ATTACHMENT II TO IPN-99-015
SAFETY EVALUATION FOR
PROPOSED TECHNICAL SPECIFICATION CHANGES
REGARDING CONTROL ROD MISALIGNMENT
AND ROD POSITION INDICATION

NEW YORK POWER AUTHORITY
INDIAN POINT 3 NUCLEAR POWER PLANT
DOCKET NO. 50-286
DPR-64

SAFETY EVALUATION OF TECHNICAL SPECIFICATION CHANGES REGARDING
CONTROL ROD MISALIGNMENT AND ROD POSITION INDICATION

This application for amendment to the Indian Point 3 Technical Specifications proposes to amend Sections 3.10.5 and 3.10.7, and the Bases of Appendix A of the Operating License. The proposed amendment would permit increasing the indicated control rod misalignment from the current limits to an indicated misalignment of ± 24 steps when the core power is less than or equal to 85% of rated thermal power (RTP) and ± 12 steps above 85% of RTP with the following considerations: when the group step counter (GSC) demand position exceeds the top of active fuel (TAF) at about 225 steps, the acceptable deviation on the negative side (i.e. when analog rod position indicator is below GSC demand position) may increase by 1 step for every additional step of GSC demand position; when the GSC demand position is below the TAF by no more than 12 step

Figure 3.10-1

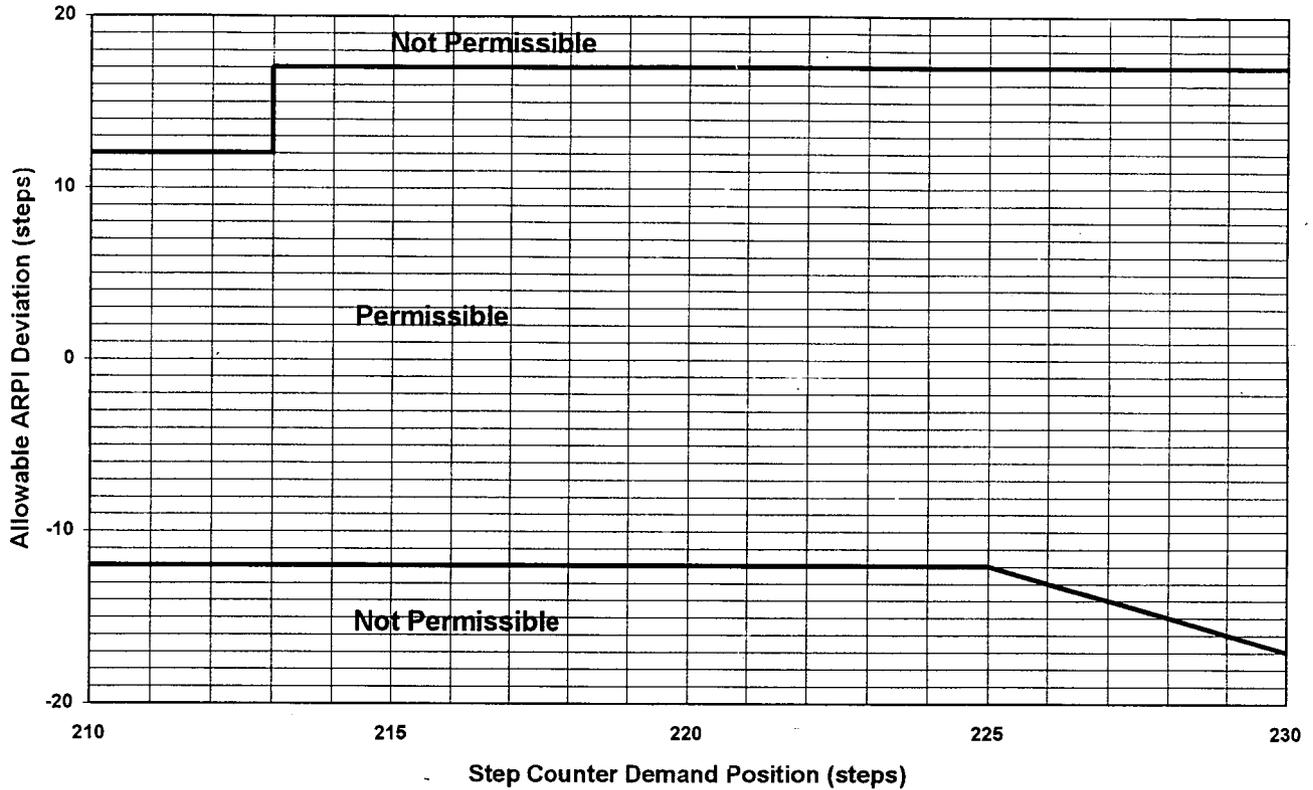
- b. For operation greater than 85% of rated thermal power, the indicated misalignment between the group step counter demand position and the analog rod position indicator for each control or shutdown rod shall be within the limits of Figure 3.10-1. This allowable deviation may be increased by up to an additional six steps (indicated on Table 3.10-1) as a function of peaking factor margin $F_Q(Z)$ and $F_{\Delta H}^N$. A control or shutdown rod indicating a misalignment greater than that allowed by this specification shall be realigned within one hour or the core peaking factors shall be determined within two hours and the requirements of Specification 3.10.2 applied.

b) to within the varying allowable deviations shown in Figure 3.10-1 for power level greater than 85% of rated thermal power. This may be extended up to an additional six steps in either direction if sufficient peaking factor margin exists;

The allowable deviation shown in Figure 3.10-1 varies as a function of bank demand position allowing for the top of active fuel ending at a control rod position of approximately 225 steps. Also above 85% of rated thermal power, if sufficient peaking factor margin is demonstrated by satisfying the requirements of Table 3.10-1, the acceptable deviation is increased by up to an additional 6 steps depending upon peaking factor margin, (e.g. for an allowable increase of 6 additional steps from indicated misalignment, the peak measured $F_Q(Z)$ from the most recent, current cycle, full power (i.e. $\geq 98\%$ Rated Thermal Power) incore flux map must be at least 3.0% less than the limit AND the peak measured $F_{\Delta H}^N$ from the most recent, current cycle, full power incore flux map must be at least 2.0% less than the limiting value).

For group step counter demand positions greater than 212 steps withdrawn, it is acceptable for the analog rod position indicator to indicate misalignment greater than +12 steps (as indicated on Figure 3.10-1) without accounting for peaking factor margin. This is due to the top of active fuel stack being at approximately 225 steps withdrawn. Indicated misalignment in the more withdrawn direction should result in the actual rod position being no lower than 201 steps withdrawn (which is within the analyzed limits). Actual control rod positions above the top of active fuel will not result in increased peaking factors for increased misalignments.

Similarly, allowable negative deviation limits may increase by 1 step for every step of group step counter demand position over the top of active fuel.

Add Figure 3.10-1, Permissible Rod Misalignment vs. Step Counter Demand Position, >85% Of Rated Thermal Power

For operation at power levels above 85% of RTP, the evaluation concludes that the degree of indicated misalignment is a function of the peaking factor margin present. The margin is determined by comparing the measured $F_Q(Z)$ and $F_{\Delta H}^N$ from the most recent, current cycle, full power incore flux map with their corresponding limits. The degree of margin required for an indicated misalignment greater than that allowed by Figure 3.10-1 is defined in Table 3.10-1.

For group step counter demand positions greater than 212 steps withdrawn, it is acceptable for the ARPI to indicate misalignment greater than +12 steps (as indicated on Figure 3.10-1) without accounting for peaking factor margin. This is due to the TAF stack being at approximately 225 steps withdrawn. Actual control rod positions above the TAF will not result in increased peaking factors for increased misalignments. Similarly, allowable negative deviation limits may increase by 1 step for every step of group step counter demand position over the TAF.
